Appendix C
Certified Letter-PTC Revisions

DEPARTMENT OF THE AIR FORCE
HEADQUARTERS 366TH FIGHTER WING (ACC)
MOUNTAIN HOME AIR FORCE BASE IDAHO

In accordance with the Idaho Administrative Procedures Act (IDAPA) 58.01.01.209.04, Rules for the Control of Air Pollution in Idaho, Mountain Home Air Force Base (MHAFB) is issuing a formal REVISION OF PERMITS TO CONSTRUCT (PTC). MHAFB would like to make the following changes in the appropriate PTC:

Figure 1

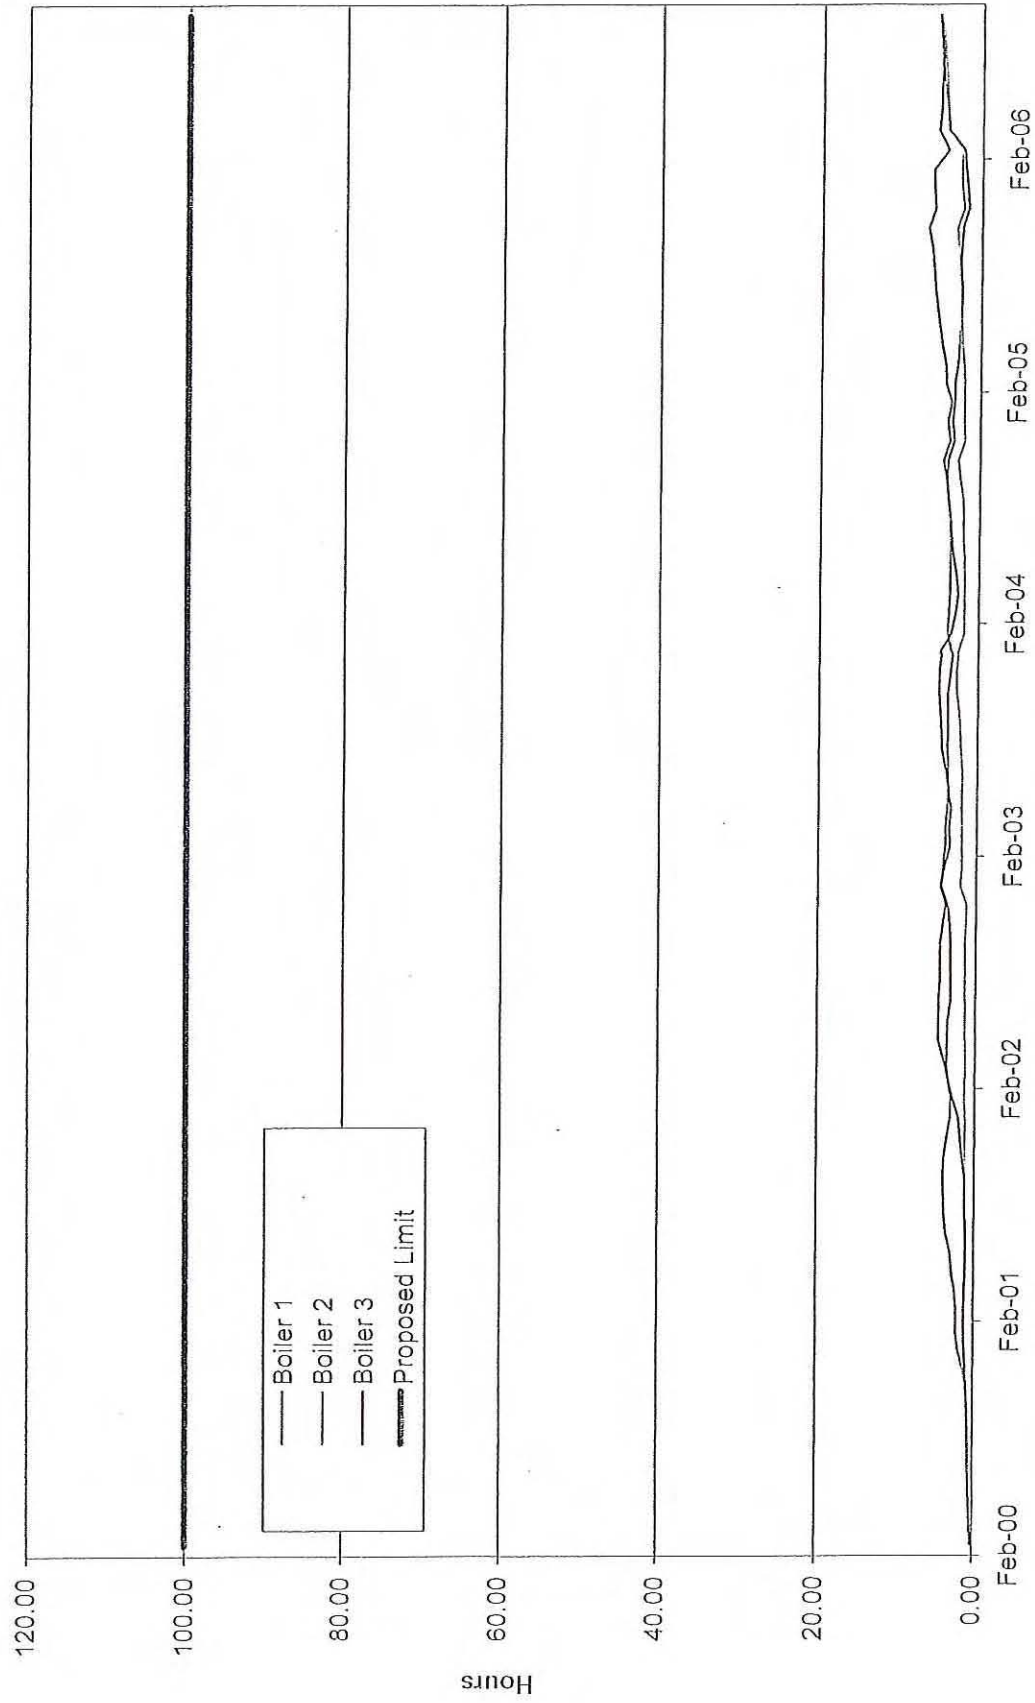
500 hours per any consecutive 12-month period when fueled by distillate fuel (Permit Condition 3.1.4). As shown in Figure 1, each of the boilers has run less than 7 hours per any consecutive 12 month period since February 2000.

Permit Condition 3.1.8 requires quarterly visible emission observations while oil is being combusted in accordance with IDAPA 58.01.01.625. Visual emissions observations are only required when distillate fuel is being combusted. Since distillate fuel is rarely used in the Kewanee boilers and then only to perform routine testing, maintenance and visual emissions observations or if there is a disruption in the natural gas supply, MHA FB is proposing to change Permit Condition 3.1.8 to the following:

Visible emissions observations shall not be required unless the permitted unit has operated for more than 100 hours per any consecutive 12-month period when fueled by distillate fuel. If the permitted unit has operated more than 100 hours per any consecutive 12-month period then the permittee shall conduct a visible emissions observation on the boiler stack quarterly, during daylight hours, while oil is being combusted for a minimum of two quarters until the permitted unit operates less than 75 hours per any consecutive 12-month period. The length of each observation shall be no less than 10 minutes. If any visible emissions are present at the time of the observation, the permittee shall conduct a visible emissions observation in accordance with IDAPA 58.01.01.625. During this observation, a minimum of thirty 15-second observations shall be recorded while the process is in operation. If opacity is greater than 20%, as determined in accordance with IDAPA 58.01.01.625, the permittee shall take all necessary corrective action and report excess emissions in accordance with Permit Condition 2.9. The permittee shall record the results of each visible emission observation, and corrective action taken, if any, and maintain the records in accordance with Permit Condition 2.11.

Figure 2

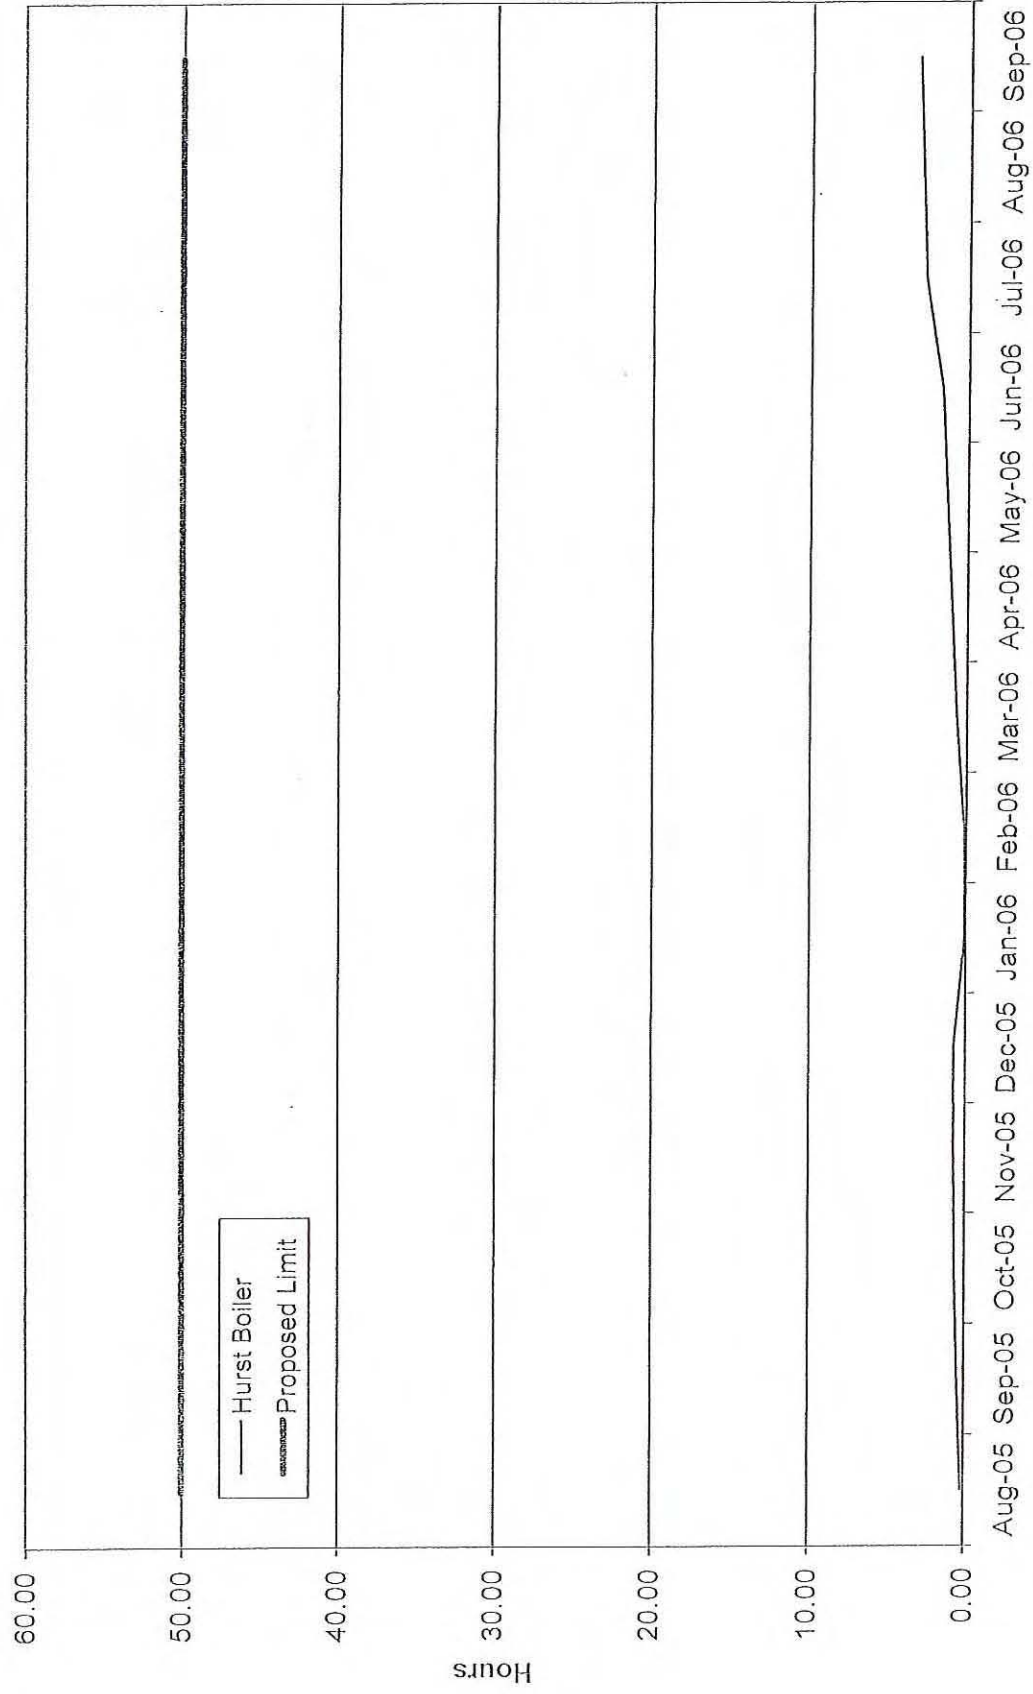
Section 3.2 is associated with the dual-fuel-fired Hurst boiler at the base hospital. The boiler is rated at 1.05 MMBtu/hr and can be operated by natural gas or distillate fuel and is permitted to operate no more than 500 hours per any consecutive 12-month period when fueled by distillate fuel (Permit Condition 3.2.4). As shown in Figure 2, the boiler has run less than 4 hours per any consecutive 12 month period. The Hurst boiler does not operate continuously. Once the boiler reaches operating pressure, it will only fire as required to maintain this pressure. There may be times that the Hurst boiler will not operate on a continuous firing to observe visible emission observations for 10 minutes.

Permit Condition 3.2.6 requires quarterly visible emission observations while oil is being combusted in accordance with IDAPA 58.01.01.625. Visual emissions observations are only required when distillate fuel is being combusted. Since distillate fuel is rarely used in the Hurst

boiler and then only to perform routine testing, maintenance, and visual emissions observations or if there is a disruption in the natural gas supply, MHAFB is proposing to change Permit Condition 3.2.6 to the following:

Visible emissions observations shall not be required unless the Hurst boiler has operated for more than 50 hours per any consecutive 12-month period when fueled by distillate fuel. If the permitted unit has operated more than 50 hours per any consecutive 12-month period then the permittee shall conduct a visible emissions observation on the boiler stack quarterly, during daylight hours, while oil is being combusted for a minimum of two quarters until the permitted unit operates less than 25 hours per any consecutive 12-month period. The permittee shall conduct visible emissions inspection of the Hurst boiler stack using the procedures contained in IDAPA 58.01.01.625 to demonstrate compliance with Permit Condition 3.2.2. Records of each quarterly inspection, including the weather conditions existing at the time of the inspection, shall be maintained in accordance with Permit Condition 2.11 and shall be made available to DEQ representatives upon request.

Figure 3

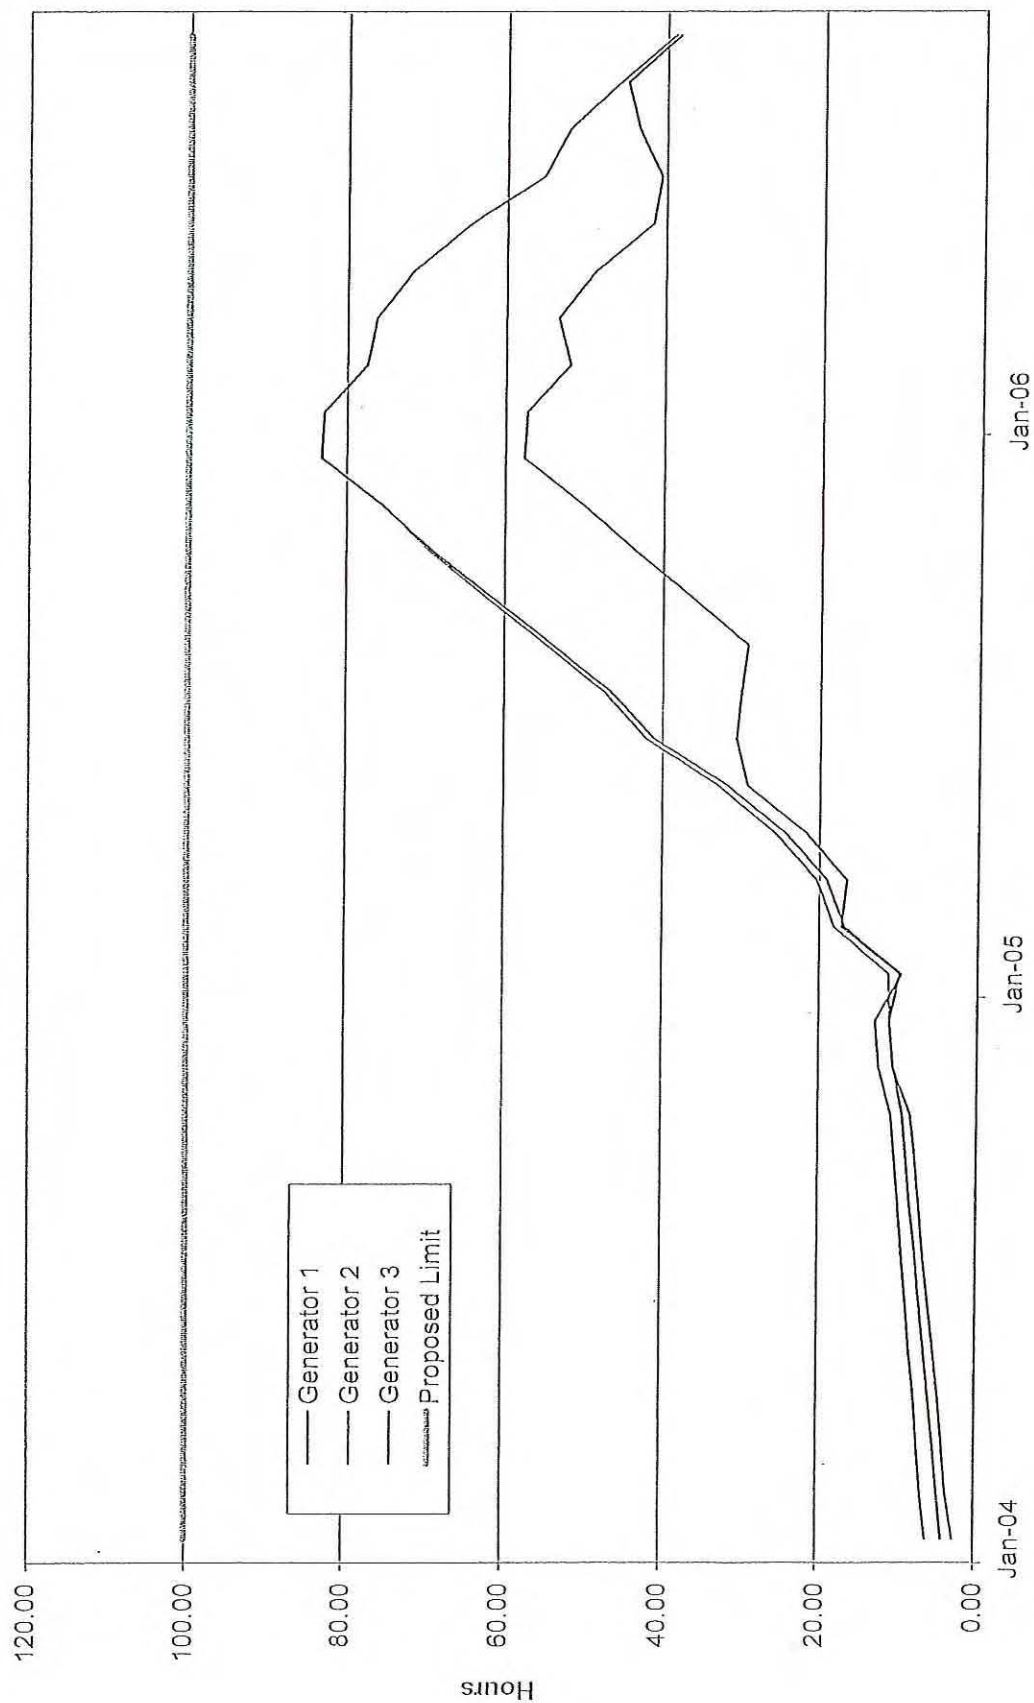
Section 10 of the permit is associated with three emergency generators located at the base hospital. Each generator is rated at 750 kW and is used for emergency back-up power. The generators are only operated for testing and maintenance or if there is a power outage. In order to maintain certain accreditations, the hospital must test the generators 12 times a year. The tests must be conducted for at least 30 minutes under a dynamic load that is at least 30% of the nameplate rating. According to Figure 3, the maximum hours of operation per consecutive 12-month period are 83 hours. This is well under the permitted limit of 500 hours per consecutive 12-month period. MHAFB is proposing to change Permit Condition 10.6 to the following:

Visible emissions observations shall not be required unless the permitted unit has operated for more than 100 hours per any consecutive 12-month period. If the permitted unit has operated more than 100 hours per any consecutive 12-month period then the permittee shall conduct a visible emissions observation on the generator stack quarterly, during daylight hours, for a minimum of two quarters until the permitted unit operates less than 75 hours per any consecutive 12-month period. The permittee shall conduct a visible emissions observation in accordance with IDAPA 58.01.01.625 to demonstrate compliance with Permit Condition 10.2. Records of each inspection, including the weather conditions existing at the time of the inspection, shall be maintained in

accordance with Permit Condition 2.11 and shall be made available to DEQ representatives upon request
